JOHN DEERE OEM SALÉS DIVISION Moline, Illinois 61265

> OEM 81-1 18 February 1981

JOHN DEERE SERIES 300 OEM ENGINES

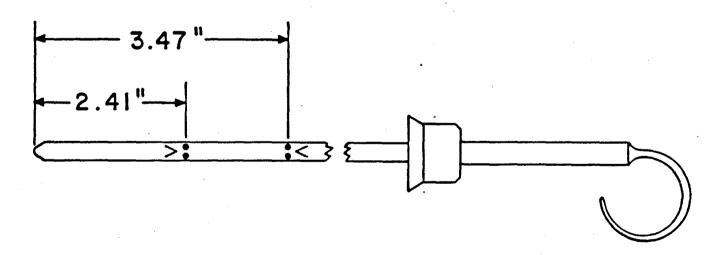
- A. All 300 Series Engines
 - 1. Oil change interval has been changed from 200 hours to 100 hours
- B. 3164D 4219D Model Engines
 - 1. Crankcase oil fill capacity has been increased from 6 to 9 quarts with filter change
 - 2. To increase the crankcase capacity of 3164D 4219D engines from 6 9 quarts either remark the present AT21534 dipstick (see sketch) or install a new dipstick part number AR78192.
